**ADDENDUM  
NO. 9**

**June 17, 2022**

**Greenfield Central High School Auditorium Renovation and  
Addition – Bid Package No. 2  
810 N. Broadway  
Greenfield, IN 46140**

**PROJECT: GREENFIELD CENTRAL – AUDITORIUM RENOVATION AND ADDITION**

**1 UNDERFLOOR DUCT BACK FILL DETAIL**  
SCALE: NONE

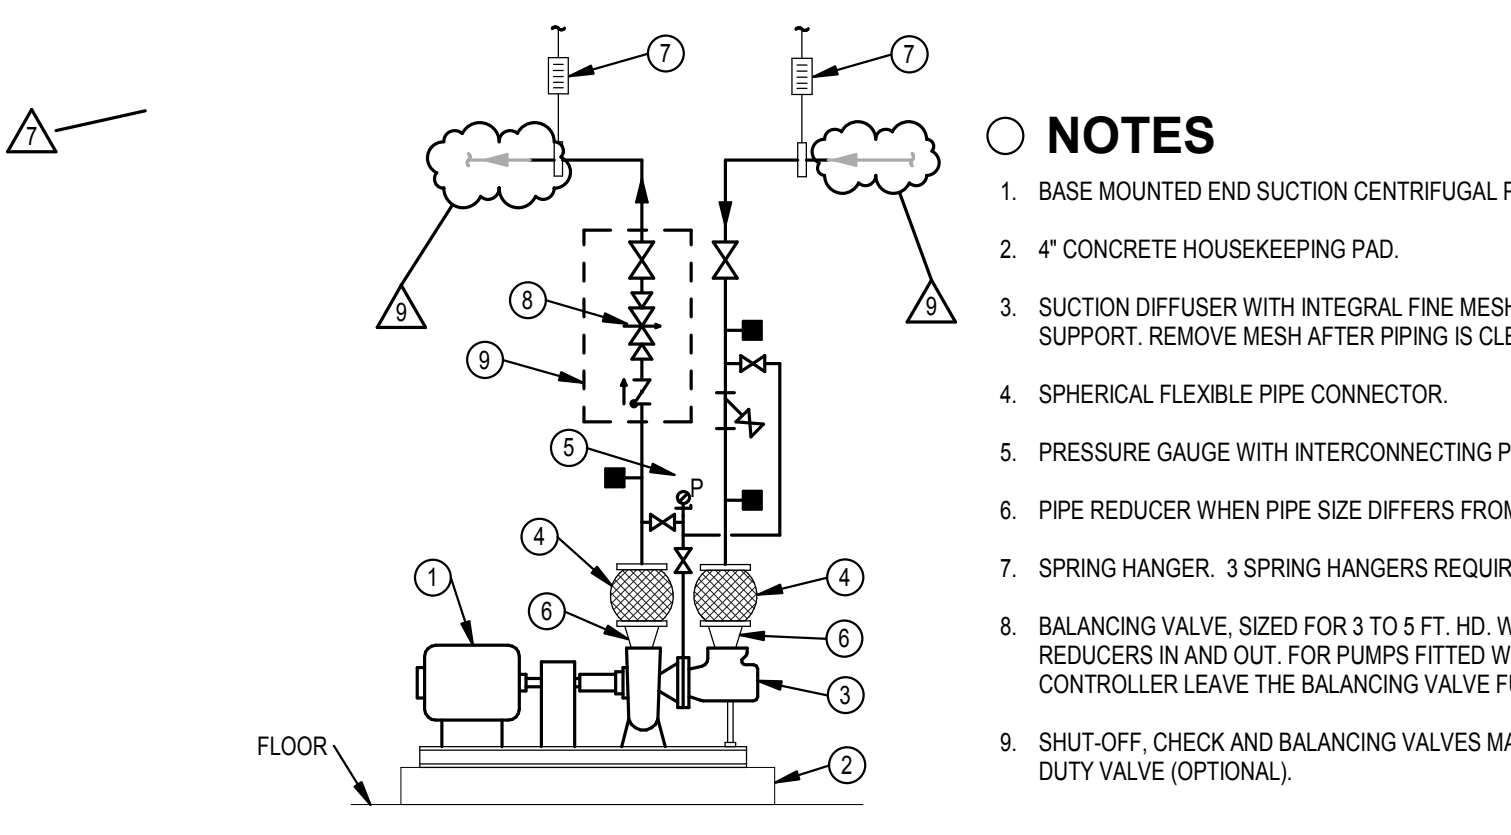
- ITEM NO. 21 M502 - MECHANICAL DETAILS
  - A. Modify underfloor duct back fill detail.
  - B. Modify base mounted pump detail.
- ITEM NO. 22 M601 - ATC LEGEND

**DUCT REHEAT COIL ATC DIAGRAM - H.W. REHEAT**  
SCALE: NONE

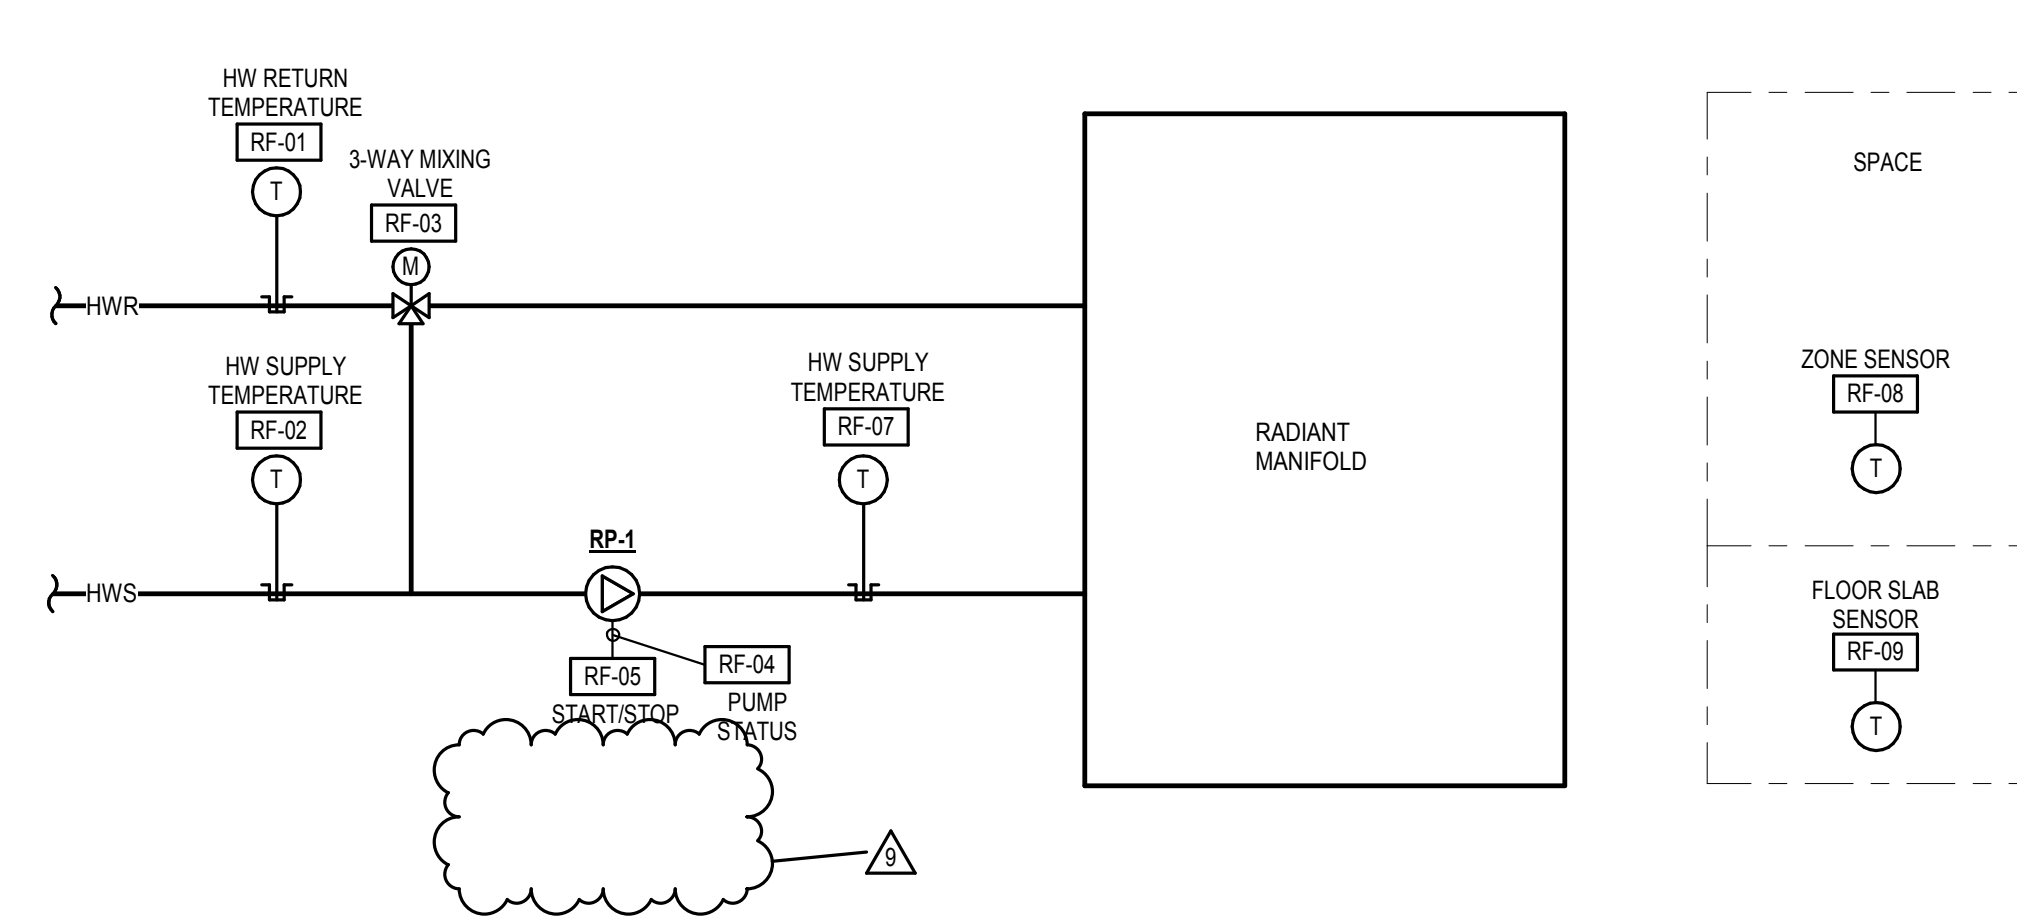
- A. Modify sequence of operations.
- ITEM NO. 25 M604 - ATC DIAGRAMS
  - A. Modify sequence of operations.
- ITEM NO. 26 M605 - ATC DIAGRAMS
  - A. Add duct reheat coil diagram.

**RADIANT FLOOR ATC DIAGRAM**  
SCALE: NONE

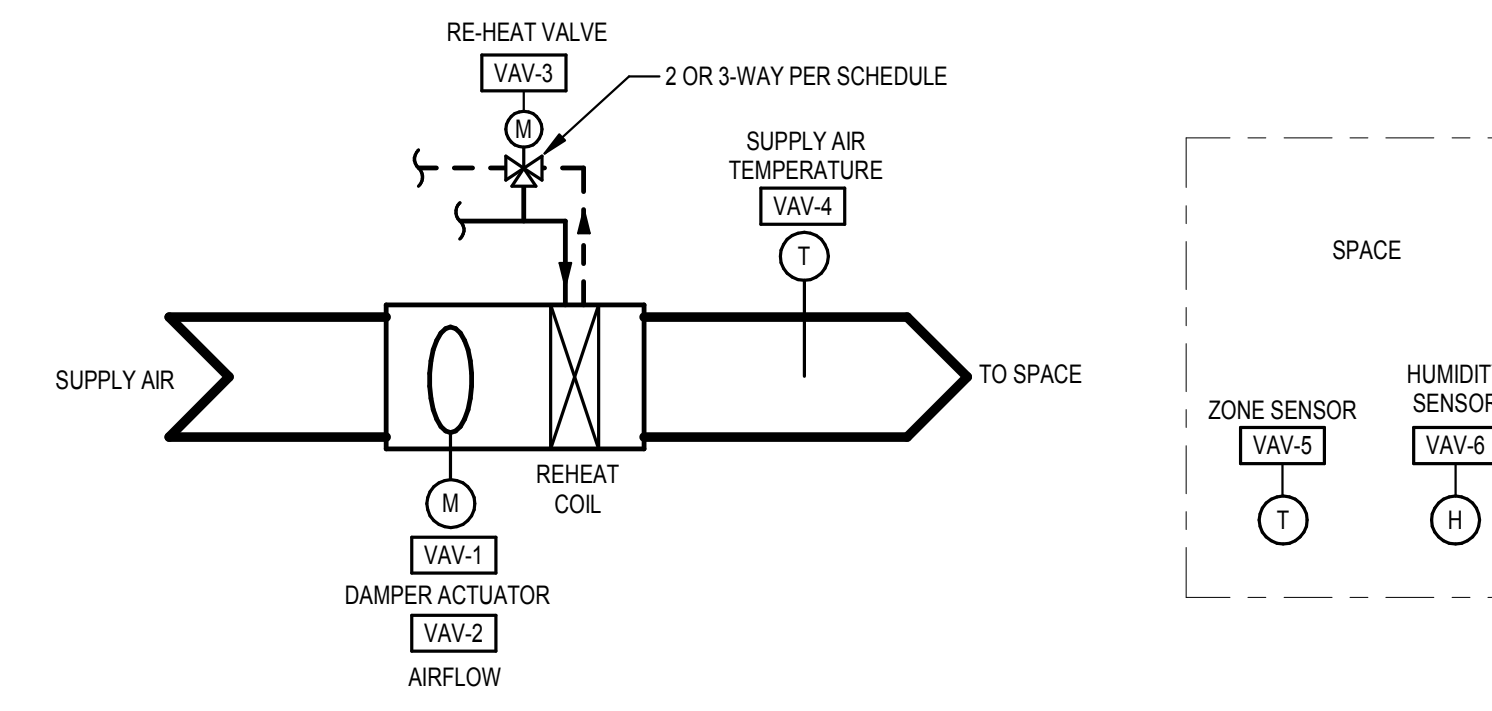
- B. Modify radiant floor diagram.
  - C. Modify air terminal unit diagram.
- ITEM NO. 27 M701 - MECHANICAL SCHEDULES
  - A. Modify schedules. Refer to drawing.
